ADDENDUM 3

DATE: November 18, 2016
PROJECT: MSB First Floor Infill LRC 3 & 4
RFP NO: 744-R1705
OWNER: The University of Texas Health Science Center at Houston
TO: Prospective Proposers

This Addendum forms part of and modifies Proposal Documents dated, October 19, 2016, with amendments and additions noted below.

Equipment First Level Plan - East 1/4" = 1'-0" 3

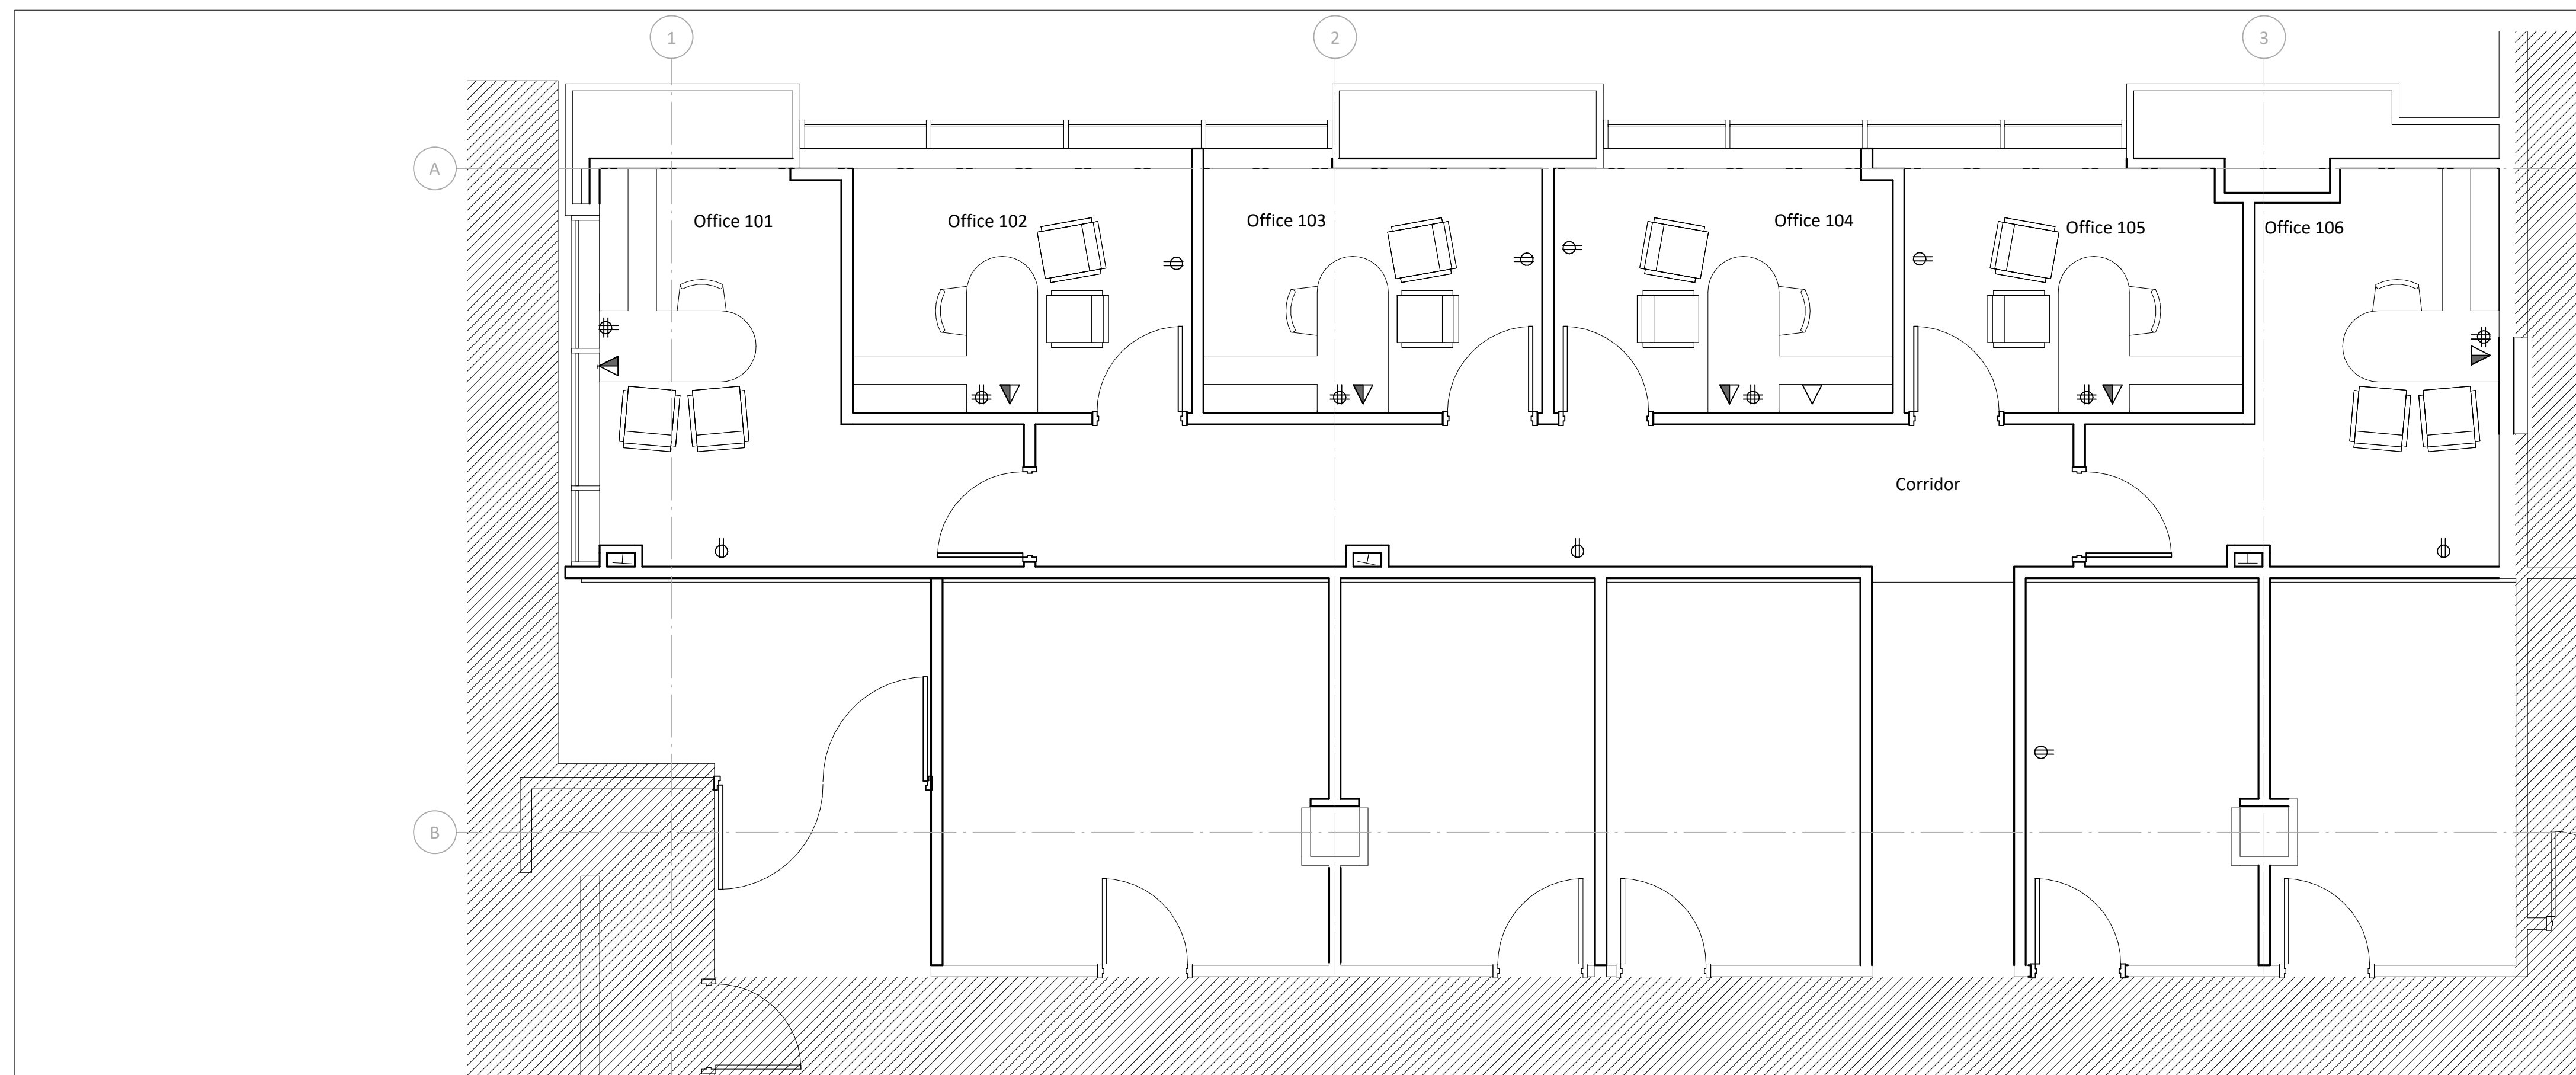
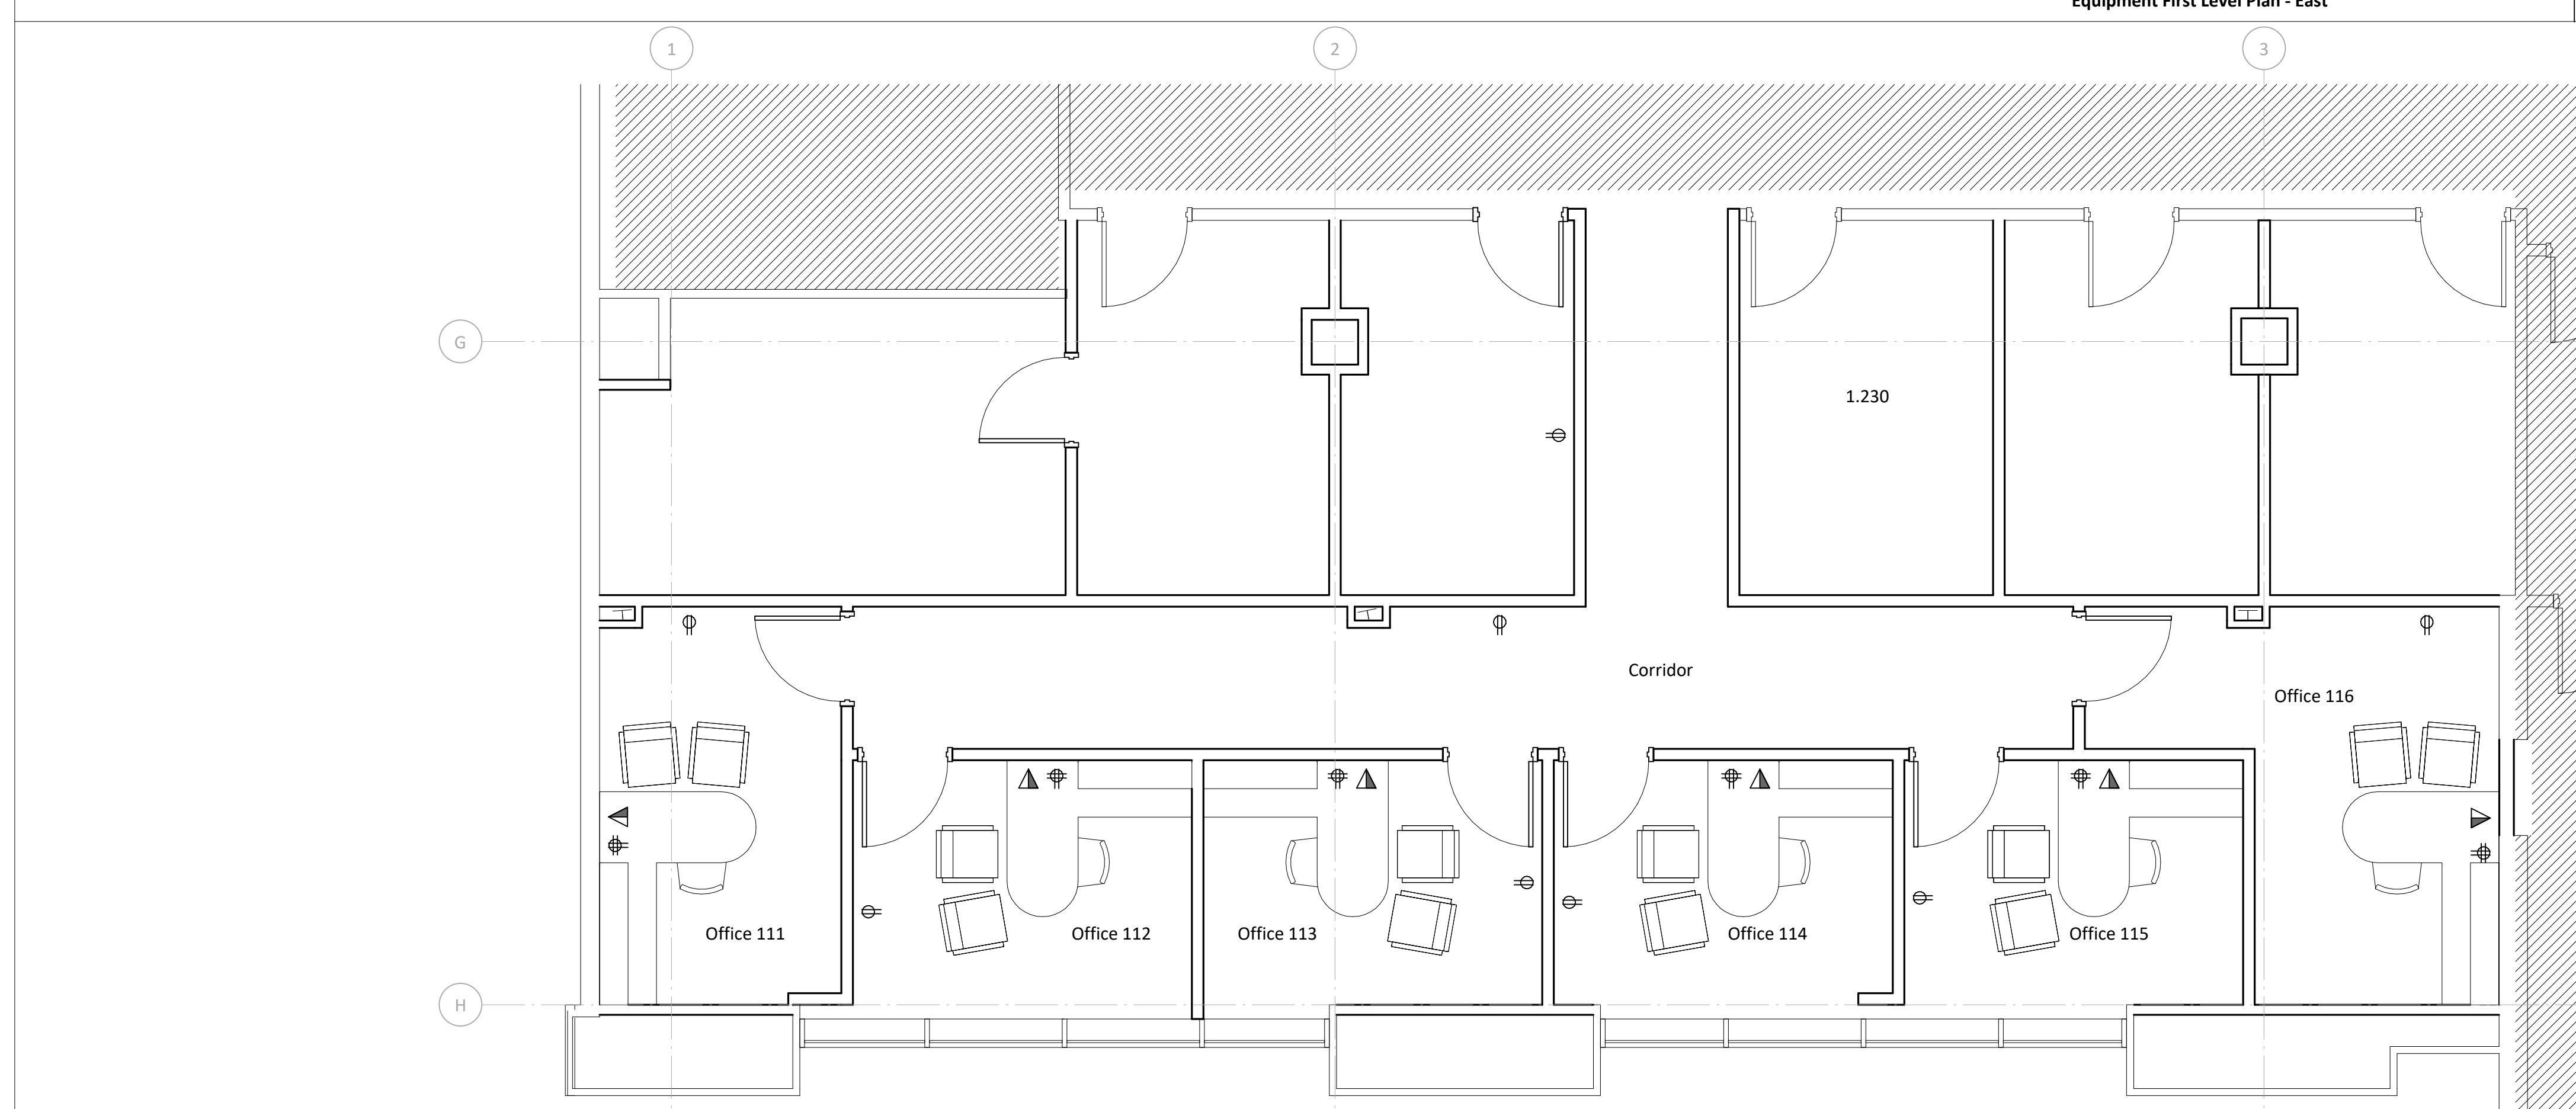
26. On drawing A-130 – Please advise if blocking will be required for the furniture shown on A-130.
Yes, check with manufacturer before installing
27. On drawing A-540 – Please provide VCT 1 color
Armstrong Imperial Texture 51810 Washed Linen

Note: Provide 2'-3" x 5'-0" blocking for new offices and existing offices receiving new furniture.
